#### **THM 4T60-E**

# TAPERED ROTOR PUMP CASTING IDENTIFICATION AND INTERCHANGE

Figure 1
AUTOMATIC TRANSMISSION SERVICE GROUP

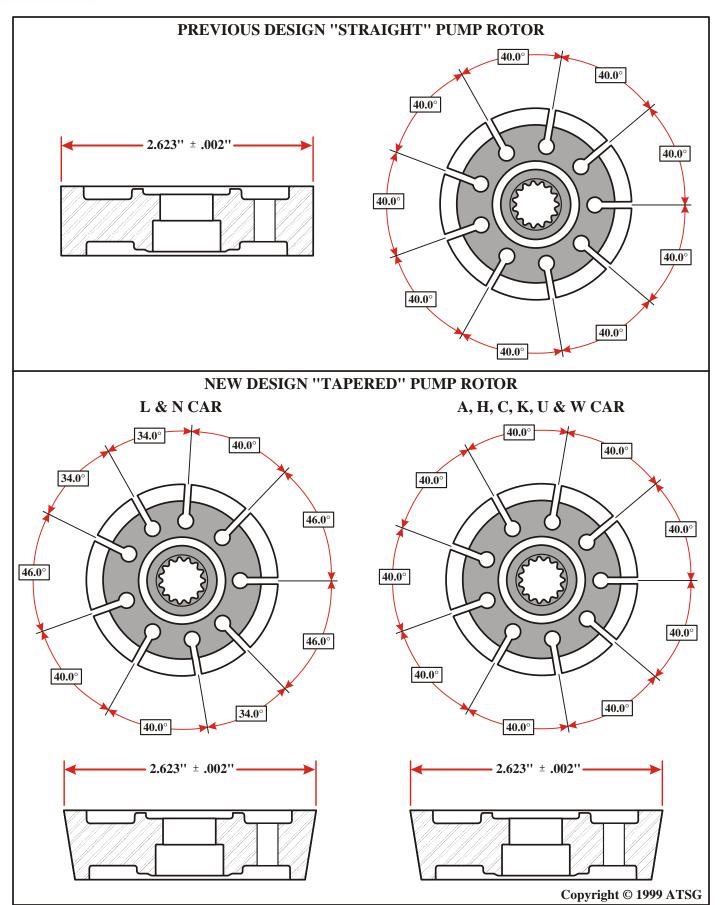
- (1) PUMP ROTOR New design is now "Tapered" instead of the previous straight rotor, as shown in Figure 1. The "L" Body and "N" Body vehicles were built using the random spacing of the rotor vanes (34°, 40° and 46°) similar to the 4L60-E design. All other models will use a "Tapered" rotor with equal spacing of the rotor vanes (40°) as shown in Figure 1. All slides, rotors and vanes are still selective sizes.
- (2) PUMP BODY The new design pump body for the tapered rotor has the suction slot in the pump pocket re-sized and moved closer to the center hole for the oil pump drive shaft as shown in Figure 2.

Figure 2
AUTOMATIC TRANSMISSION SERVICE GROUP

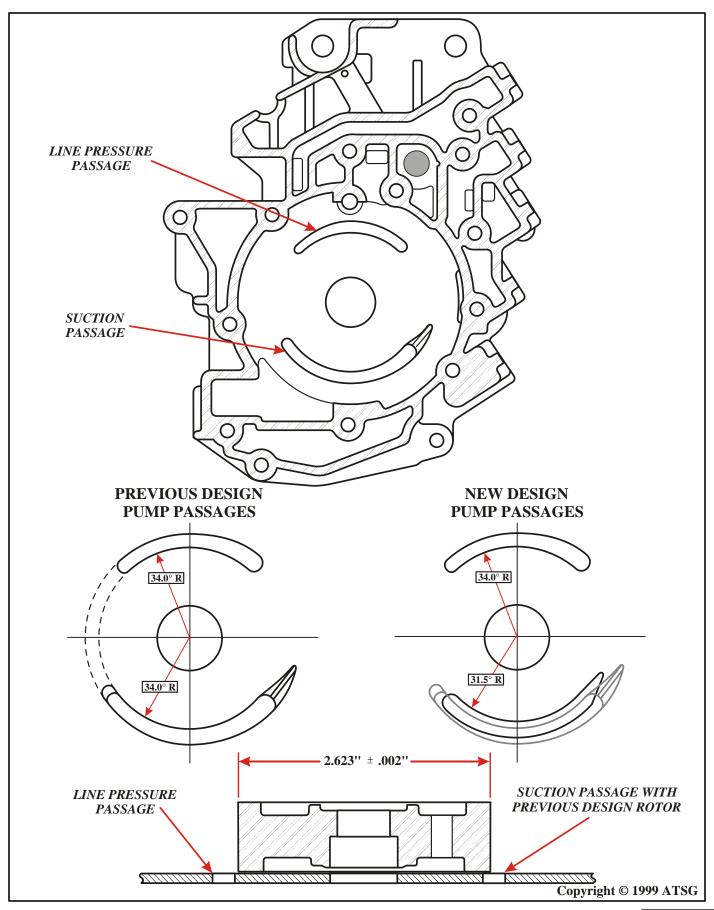
**CHANGE:** Beginning at the start of production for 1994 models, all THM 4T60-E transaxles were produced with a new design "Tapered" pump rotor and new design pump casting with location changes for the suction passage. Refer to Figures 1, 2 and 4. Beginning at the start of production for 1996 models, another new "Light Weight" pump casting was introduced that also requires the tapered rotor. Refer to Figures 1, 2 and 5.

Figure 3
AUTOMATIC TRANSMISSION SERVICE GROUP

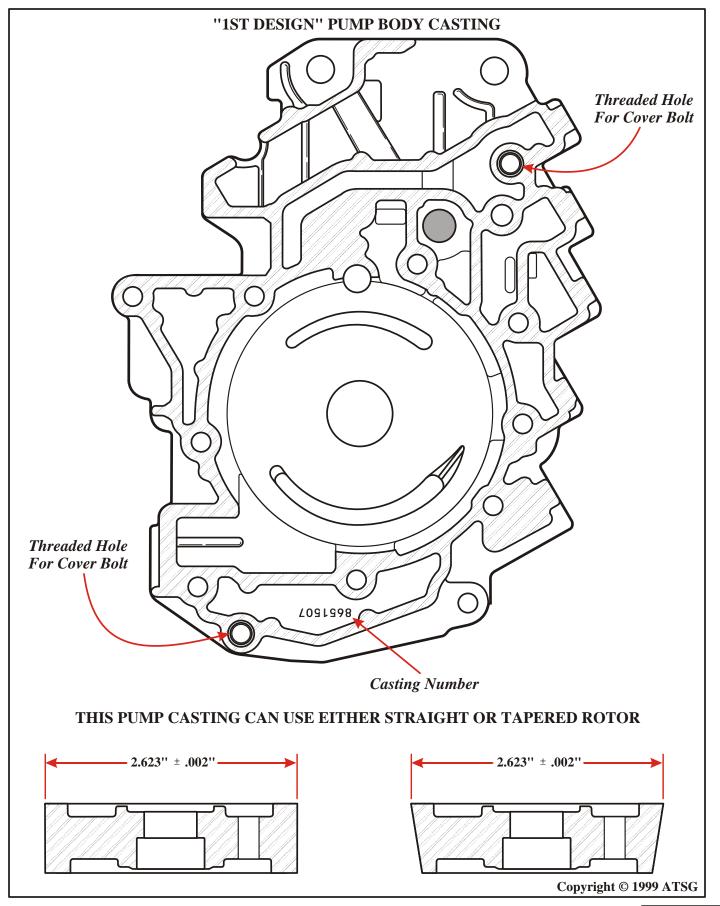
- (1) 1ST DESIGN PUMP CASTING This pump casting can use either the straight rotor or the new design tapered rotor, as the tapered rotor will retro-fit back in all models of the 4T60-E transaxle. This pump casting can be identified with the presence of two threaded holes for the pump cover and by the casting number, as shown in Figure 3.
